MINERALS PROGRAM INSPECTION REPORT PHONE: (303) 866-3567

MINE NAME:		MINE/PROSPECTING ID#:	MINERAL:	COUNTY:
Taramarcaz Pit		M-1985-072	Sand and gravel	Gunnison
INSPECTION TYPE:		INSPECTOR(S):	INSP. DATE:	INSP. TIME:
Monitoring]	Dustin M. Czapla	June 19, 2018	09:30
OPERATOR:		OPERATOR REPRESENTATIVE:	TYPE OF OPERATION:	
Gunnison County		None	110c - Construction Limited Impact	
REASON FOR INSPECTION:		BOND CALCULATION TYPE:	BOND AMOUNT:	
Normal I&E Program		None	No Bond Held	
DATE OF COMPLAINT:		POST INSP. CONTACTS:	JOINT INSP. AGENCY:	
NA		None	None	
WEATHER:	INSPEC	TOR'S SIGNATURE:	SIGNATURE DATE:	
Clear	06		June 21, 2018	
	4

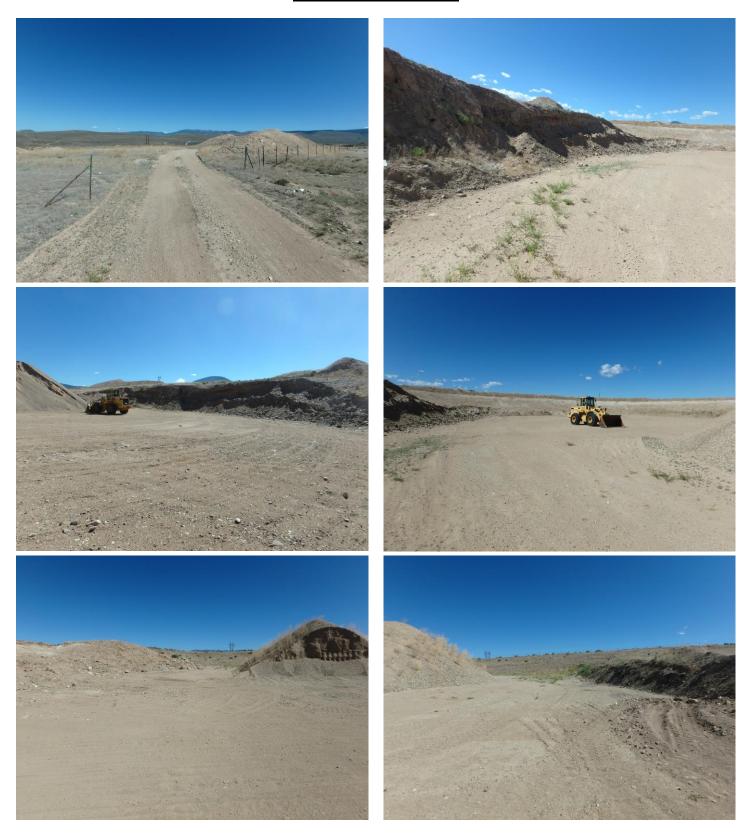
Adequate mine identification signage was not noted at the entrance to the site. This has been noted as a problem.

The affected area was marked by fencing that was clearly visible and adequate to delineate the affected area boundary.

CORRECTIVE ACTIONS: The operator shall, at the entrance of the mine site, post a sign which shall be clearly visible from the access road with the following: the name of the operator, a statement that a reclamation permit for the operation has been issued by the Colorado Mined Land Reclamation Board; and the permit number. The operator shall submit photo documentation that a proper sign has been posted by the corrective action date.
